Divine, A Boutique Medspa is a full service medical spa specializing in non-surgical cosmetic services such as botox, dermal fillers, laser services, body contouring, aesthetic services and more. Currently located at 3735 S. Lindbergh Blvd. in Sunset Hills, MO, they plan to build a new home at 4400 South Lindbergh. Generally, their hours will be everyday 9am – 7pm, except for Sunday.

**RE: Divine Med Spa  
4400 S. Lindbergh**

Re: Divine Med Spa – 4400 S. Lindbergh Blvd.  
Preliminary Site Plan Basic Conceptual Review  
MSD Ref. No. 25CNCPB-00037

Re: Divine Med Spa Application to Planning Commission  
4400 South Lindbergh  
Sunset Hills, Missouri

DRAWING NO.  
**SDP1**

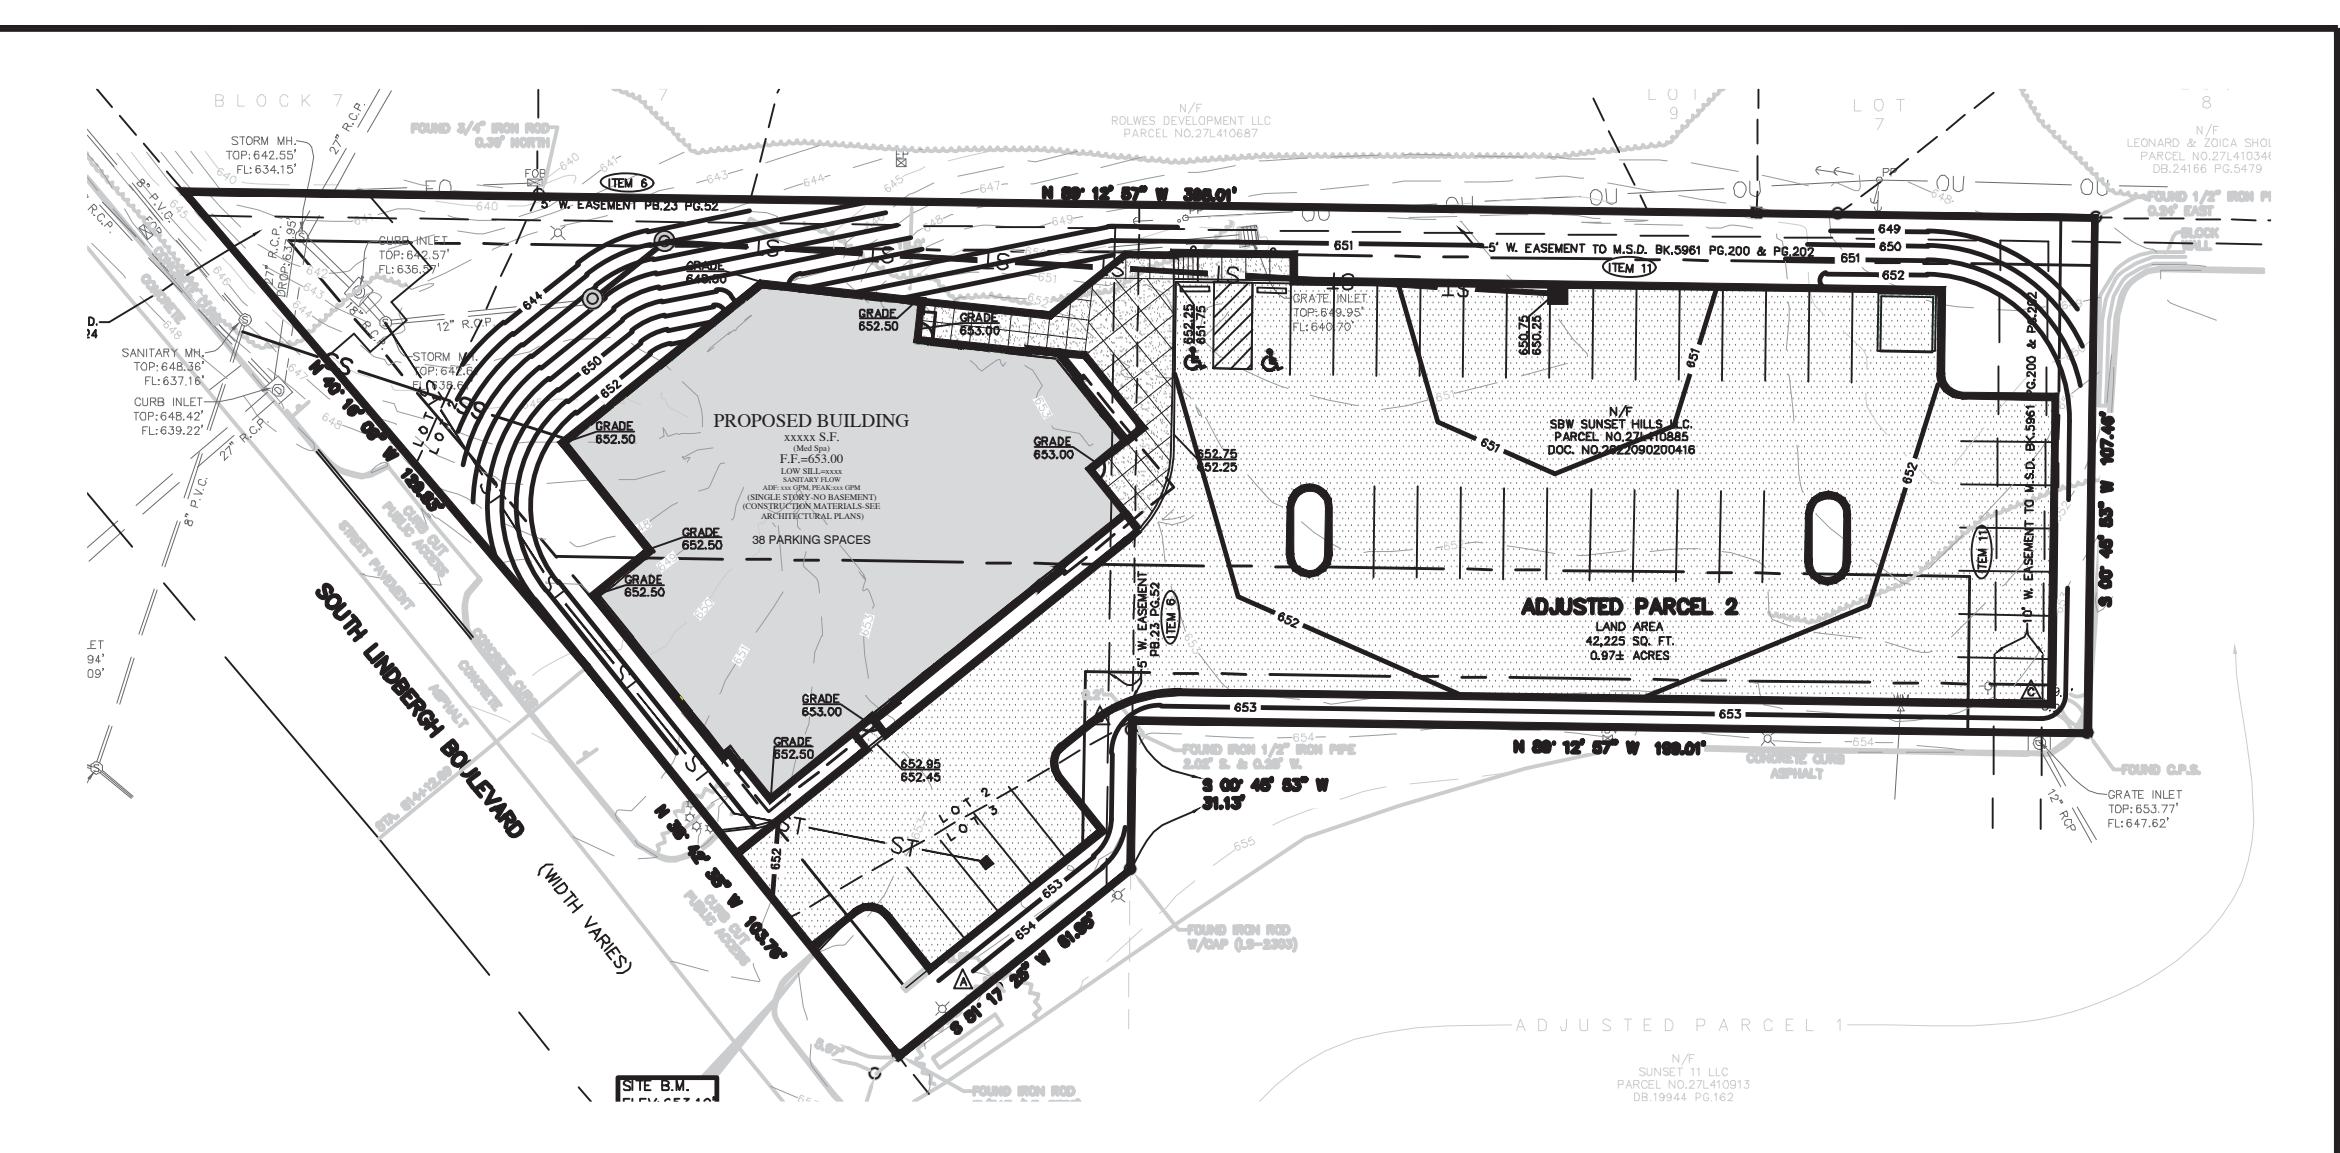
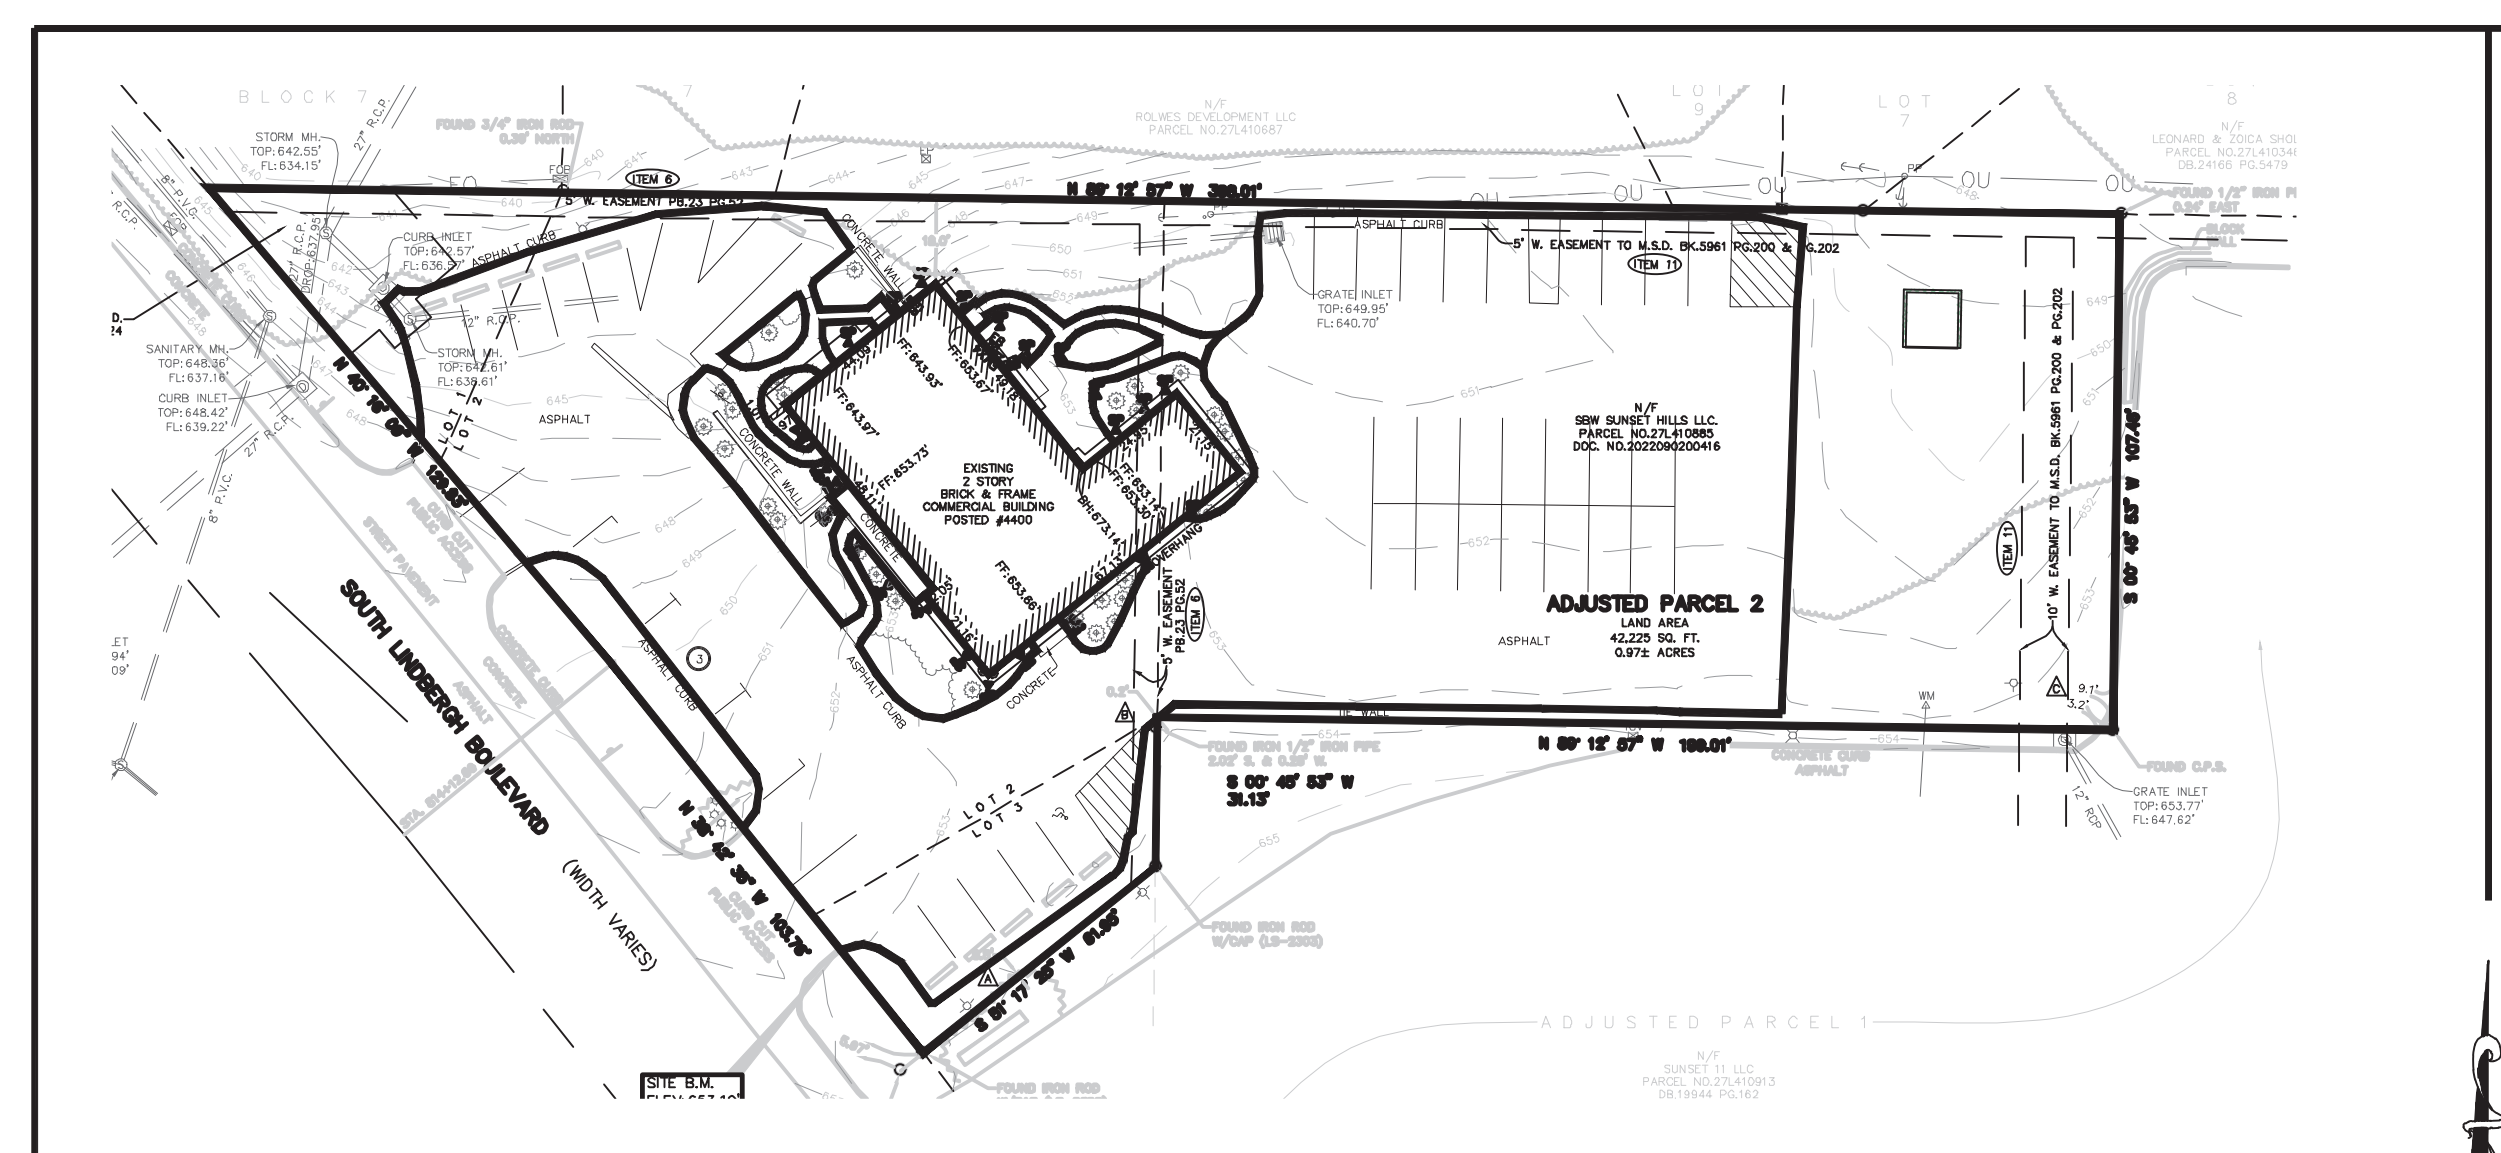
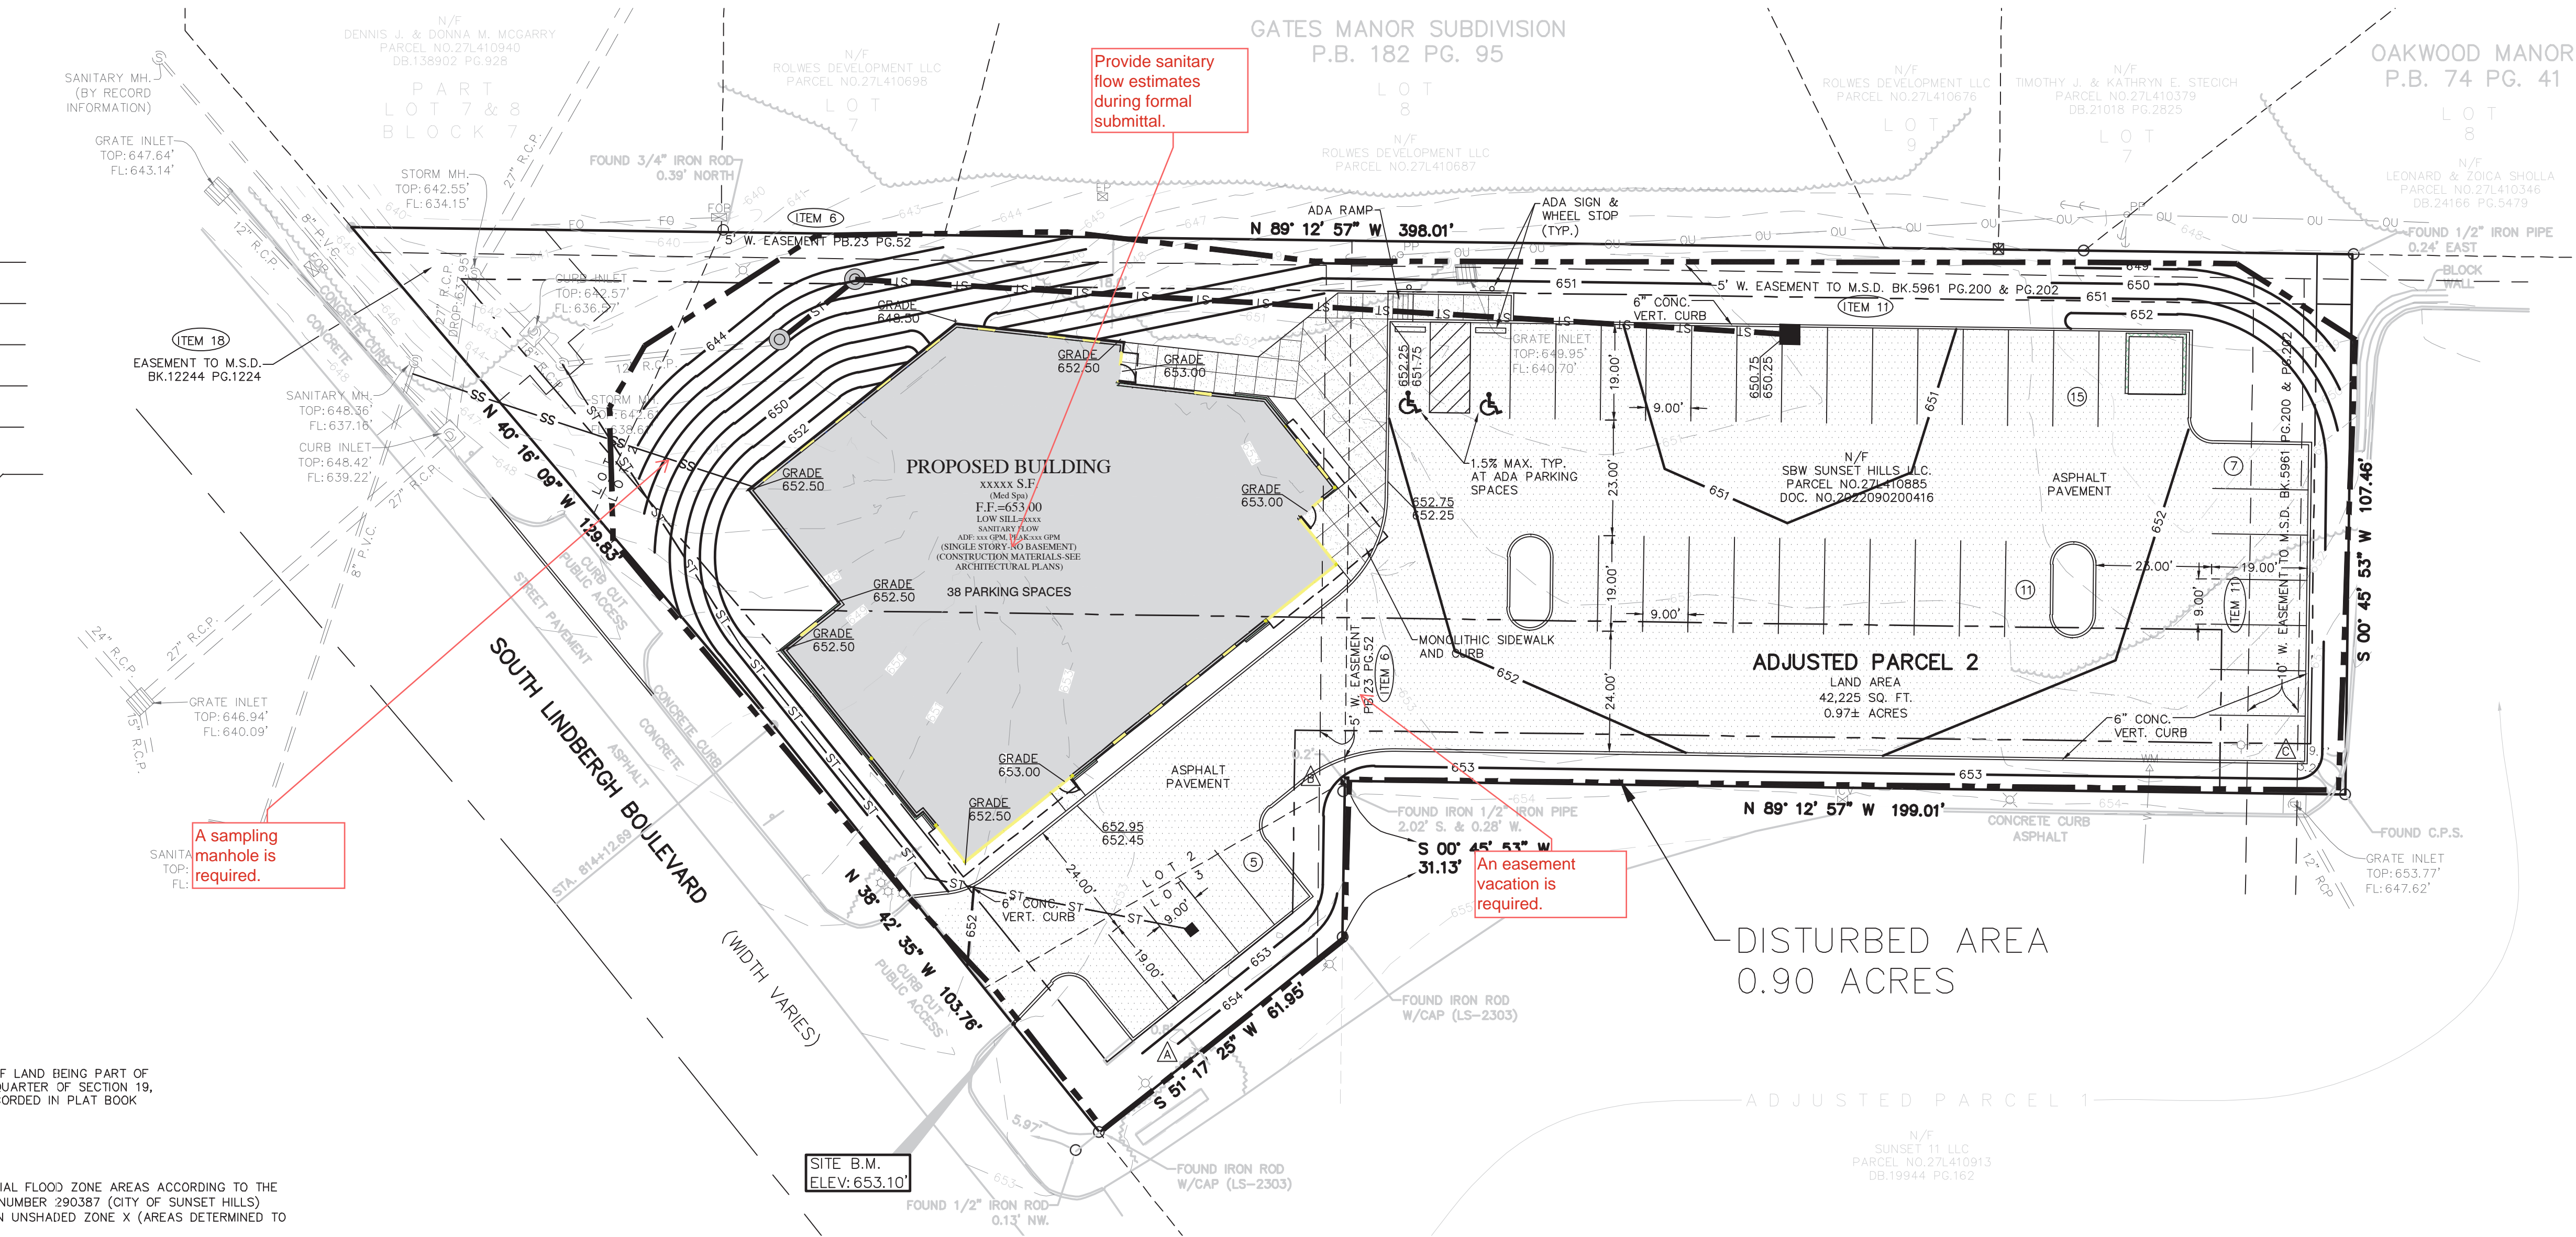
2. Fixed and permanent wheel stops securely anchored into the ground shall be installed for each parking stall which is located along the perimeter of any off-street parking area. Provide and label the wheel stops similar to the current ADA spots.
  - **Wheel stops added**

3. Provide a note on the plan or label accordingly that the curb cut not being utilized to be removed.
  - **Noted added “Existing Drive Entrance to be Removed”**

4. The minimum parking aisle required in city code is 24’ wide per Section UDO Section 4.1.8. The proposed northern drive aisle is 23’ wide. Amend accordingly.

6. Please provide the electric (Ameren), water (MAWC) and gas (Spire) utility service locations on the site plan.
  - **Water, Gas & Electric are now shown**

7. I am having a hard time understanding the proposed building setback images (both on the plan and example image on plan sheet). Specifically, the plan references 39.65’, and 13.17’ but the zoning analysis sheet depicts 39’ and 13’ and the southern setback does not appear to parallel the property line. Update the setback lines to be the distances from the exterior property lines. Purely advisory, there could be benefit in leaving some additional room on the southern setback in case a minor addition was ever contemplated.

- **The setback exhibit now only shows the requested setbacks. The previous version was showing the current and the requested**
8. Please clarify what the line in the image below in yellow is representing neighboring the parking space.

- **Two drive aisles were changed to 24’ wide**
5. Either ground-mounted or roof-mounted mechanical units are required to be screened from the general public view. Please depict the location of the units and required screening.

- **The line is a set back line**
